REMARKS

AMENDMENTS TO THE DRAWINGS:

Fig. 10

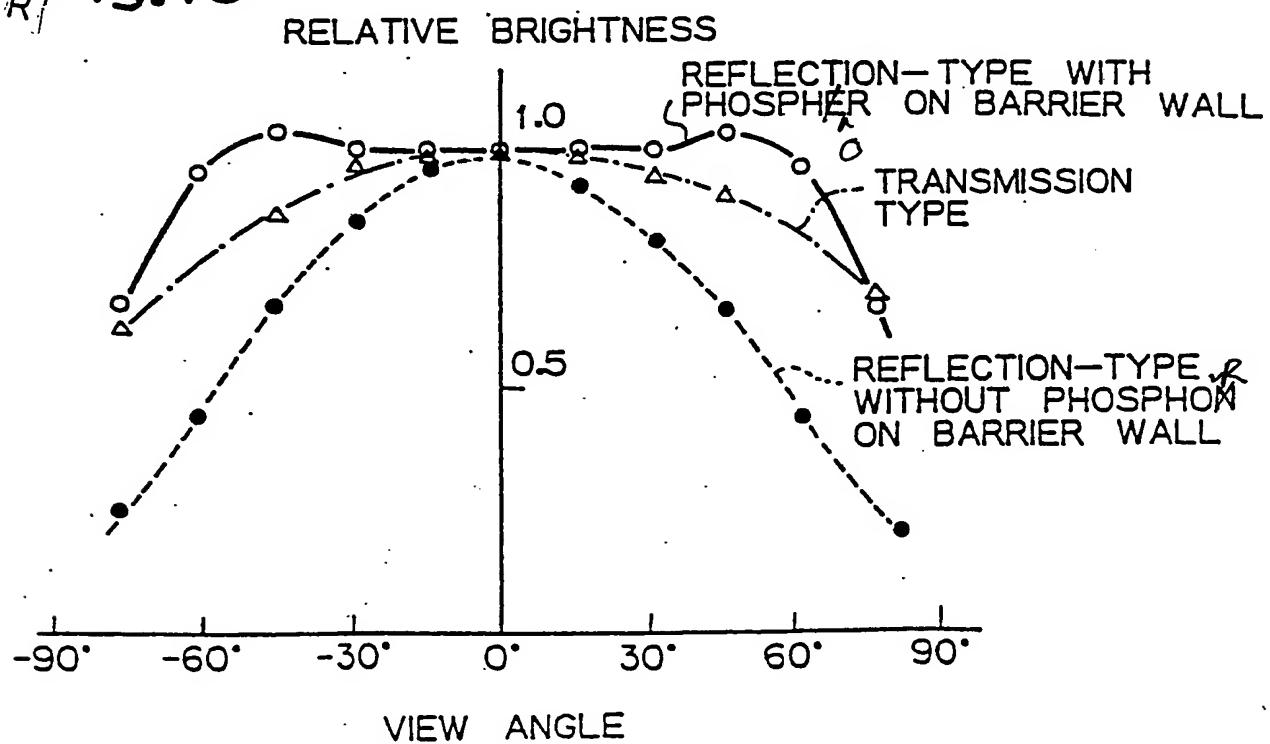
Further, FIG. 10 is changed as shown in red ink to correct for two related typographical errors and a corrected formal sheet of drawings including FIGS. 9 and 10 is submitted. Additionally, corrections are made in the drawings of FIGS. 19A, 19C, and 19F as shown by red ink annotations, as explained above.

Fig. 19A

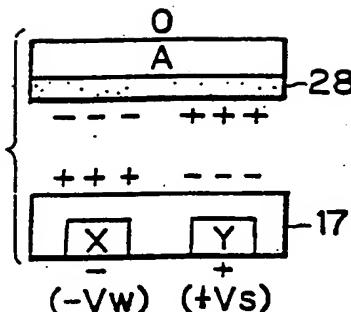
The attached drawing(s) include changes to FIGS. 19A, 19C and 19F. The sheet containing FIGS. 19A, 19C, and 19F replaces the original sheet including FIGS. 19A-19H.

As explained in the specification paragraph [00116], a positive discharge sustain Voltage V_s is applied to both display electrodes X and Y, resulting in a positive pulse base potential $+V_s$ on both the X and Y display electrodes. As next explained in paragraph [00117], a pulse PW applied to the display electrode X places it at a predetermined negative potential $-V_w$, as shown in FIG. 19A. However, no change has occurred in the potential on the Y electrode which accordingly remains at a predetermined positive voltage $+V_s$. Accordingly, in FIG. 19A, on the electrode Y the incorrect $-V_s$ has been changed to $+V_s$. The respective, opposite polarities of the voltages on electrodes X and Y shown in FIG. 19A, furthermore, are consistent with the respective, opposite polarity charges stacked on the surface of the dielectric layer above the display electrodes X and Y -- i.e., positive charges are stored above the X electrode and negative charges are stored above the Y electrode, as explained in paragraph [00118].

Fig. 19C

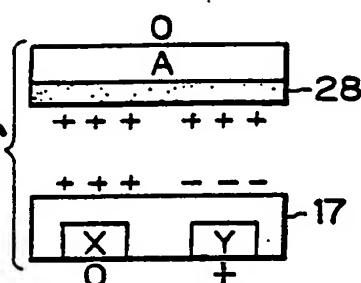
The change in FIG. 19C, similarly, is consistent with the explanation of operation in paragraph [00120], in which the respective ("+" and "0") charges on electrodes X and Y shown in FIG. 19B are reversed (i.e., to "0" and "+") respectively on the X and Y electrodes in FIG. 19C, as now corrected.

Fig. 19F

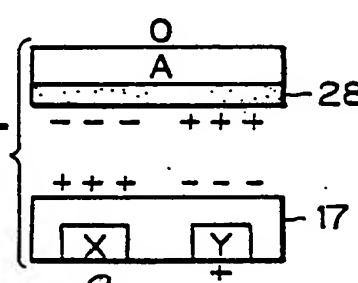
Finally, the respective polarities of the charges on electrodes X and Y in FIG. 19F are reversed from those in FIG. 19E and accordingly, a "0" should appear beneath the electrode X in FIG. 19F, as shown in the corrected FIG. 19F; see, paragraphs [00124] and [00125].
